RE: Proposed Modification To The Mine Design For Underground Right-of-Way
(R-O-W) No. U-66838

MINOR MODIFICATION TO MINE PLAN	
Recommended By: <i>[Signature]</i> Mining Engineer	<i>1/2/91</i> Date
Conditionally Approved By: <i>[Signature]</i> Chief Solid, Minerals	<i>1/2/91</i> Date

RE: UNDERGROUND ACCESS SPECIAL-USE PERMIT

CENTRAL COAL COMPANY	
CRANDAL CANYON MINE HAWKATHA SEAM PO BOX 1201 HUNTINGTON, WVA	
R.O.W. Projections	
Drawn by:	Scale 1" =
Revised:	Plate:
	Drawing:

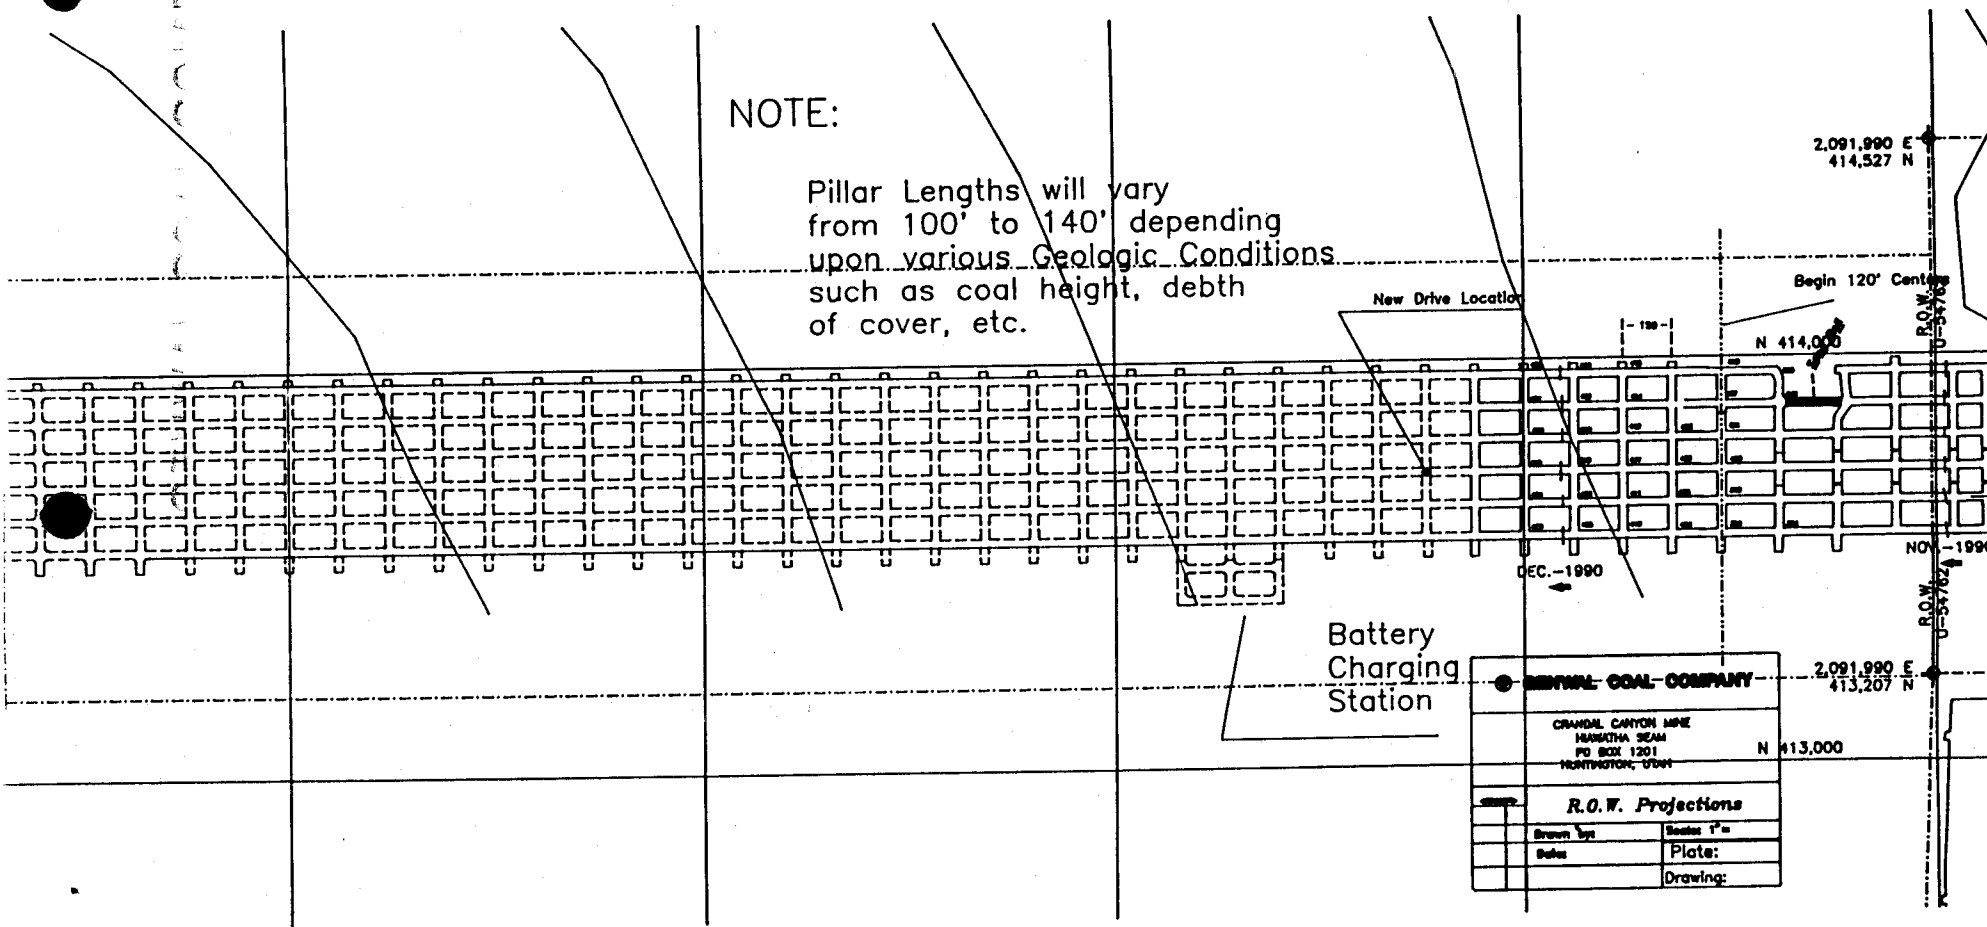
In the original submission, Genwal states that pillar dimensions were inconsistent between the narrative (80 by 160 foot centers) and the underground projection map (80 by 140 foot centers). At this time Genwal has proposed 120 foot pillar lengths that would vary between 100 and 140 feet depending on varying geologic conditions such as depth of cover and coal thickness.

Deficiencies in the original R-O-W application include car switch-outs and a battery charging station in the barrier. Genwal states that car switch-outs are necessary at each intersection to allow haulage units to switch out closer to the miner. These switch-outs consist of cuts in the barrier 40 feet deep by 20 feet wide. Also, the battery haulage used by Genwal requires a battery charging station cut in the barrier every 1,500 to 2,000 feet.

Two crosscuts into the R-O-W, a sand roll was encountered. This geologic condition was verified by our mine inspector and Genwal was given verbal permission to drop the number 6 entry for one crosscut. Genwal anticipates encountering additional sand rolls in the development of the R-O-W and has requested authorization to make similar minor entry adjustments as necessary.

Our review of all available data in the area did not reveal a wide range of geologic conditions that would warrant varying pillar sizes. Depth of overburden averages 1500 feet and gradually ranges only about 400 feet from north to south across the width of the R-O-W. We also do not have any information that indicates that coal thickness changes significantly across the R-O-W. Therefore, until additional information is submitted that would justify varying the pillar sizes, Genwal must maintain 120 foot long pillars across the R-O-W unless authorized otherwise.

The necessity for car switch-outs and battery charging stations is supported by our experience with Genwal's operation. These additions to the mine design of the R-O-W are accordingly approved as proposed.

Finally, because Genwal has provided evidence that indicates the occurrence of additional sand rolls along the R-O-W, minor adjustments to the entries are authorized for this situation. This approval is based however on Genwal promptly notifying the Price Coal Office when these conditions are encountered.

A new projection map showing pillars on 120 foot centers, car switch-outs, and the battery charging stations is included for your review.
